**YARRA CITY COUNCIL**

**Internal Development Approvals Committee**

Item		Page	Rec. Page
1.1	PLN16/0807 - 33-35 Stewart Street, Richmond - Part demolition and development of a nine storey building for use as office and retail (shop) and a reduction in the car parking requirements of the Yarra Planning Scheme.	5	45

**Attachment 1 - PLN16/0807- 33-35 Stewart Street-Decision Plans (2nd Section 57A amended plans)**

*Figure 2 and 3: Section 57A amended plans perspectives.*

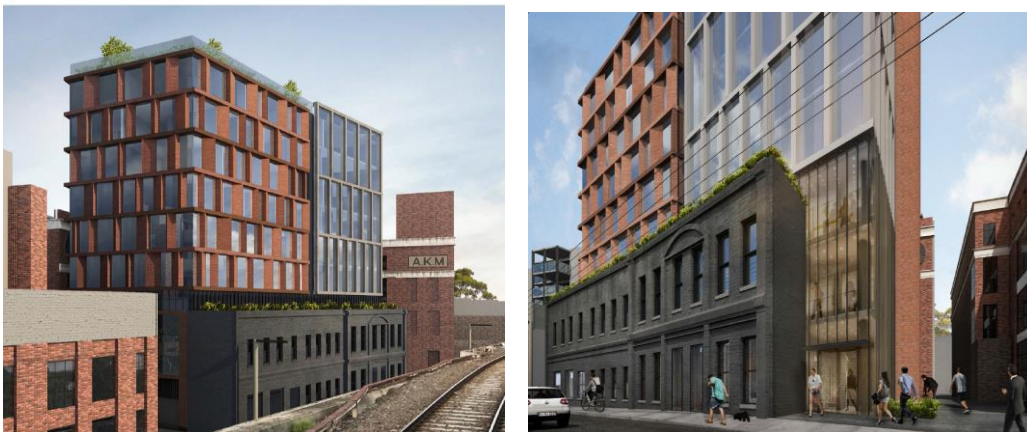
4. In response to objector and officer concerns relating to the glazed façade design and building height being out of context in heritage area, the applicant requested Council to put the application on hold to allow the applicant time to reconsider the building design. Council agreed to this. An amended application was lodged on 8 October 2018 pursuant to section 57A of the *Planning and Environment Act* (1987) (*the Act*). These plans showed the following changes:

- (a) Deletion of level reducing the building from a ten to nine storey building and removal of 3 car spaces;
- (b) Overall maximum height reduced from 33.45m to 31.76m (to top of lift overrun);
- (c) Deletion of the proposed dwellings with only office and a retail premises now proposed;
- (d) Increased setbacks to east boundary from 0.2m, 0.52m and 0.6m to 0.6m, 2.16m and 2.39m; and
- (e) Changed façade design which reduced the extent of glazing and incorporated brick and precast concrete window mullion features.

*Existing building separation between site and surrounding properties (site shown with a red \*)*

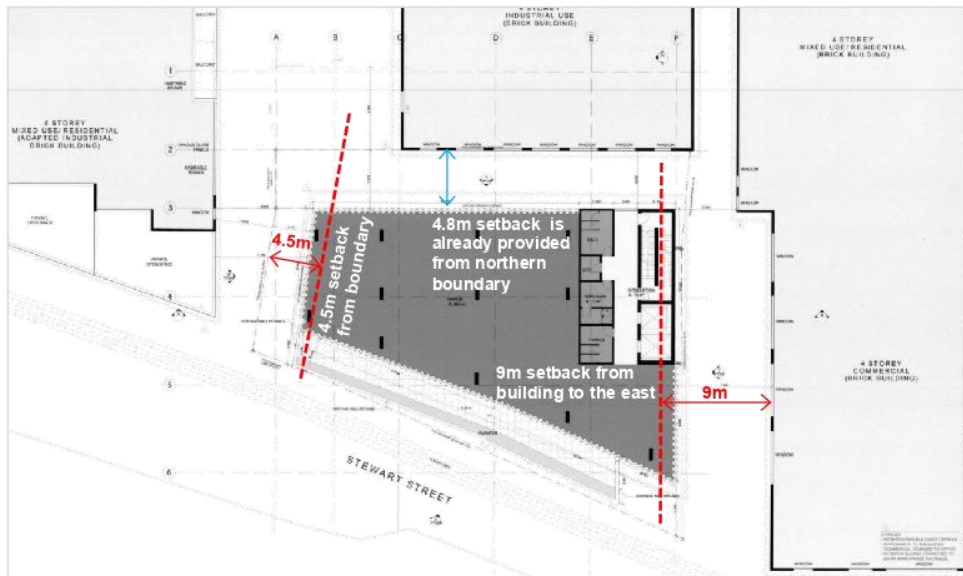
It is therefore recommended that the following setbacks be provided to the new building (as shown in red on the drawing below):

*Recommendations for substation*

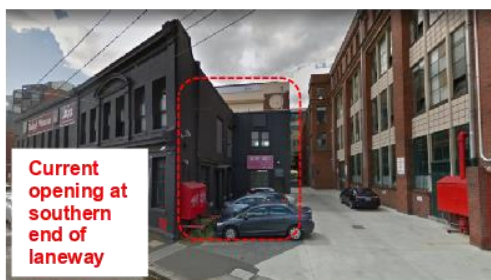
- Although the substation is within the existing heritage building, it is positioned at the front of the site and directly opposite the entrance to Richmond Station. It is recommended that the substation is moved to one of the other sides of the site away from Stewart Street, and this section of the building given to a more active use, so that some light and activity can be seen through these existing windows opposite the station.

*References to the heritage building*

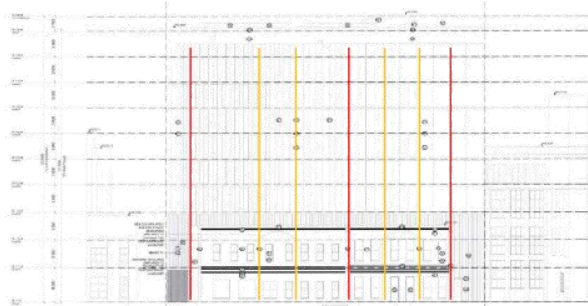
The façade provides an angled window pattern and banding along each floor level which provides some articulation and interest to the building. However given the length of the façade, it is considered that further vertical articulation should be provided to break up the mass of the front of the building and provide some references to the heritage building. The images below show some of the features/proportions of the heritage building which could be responded to in the new building.
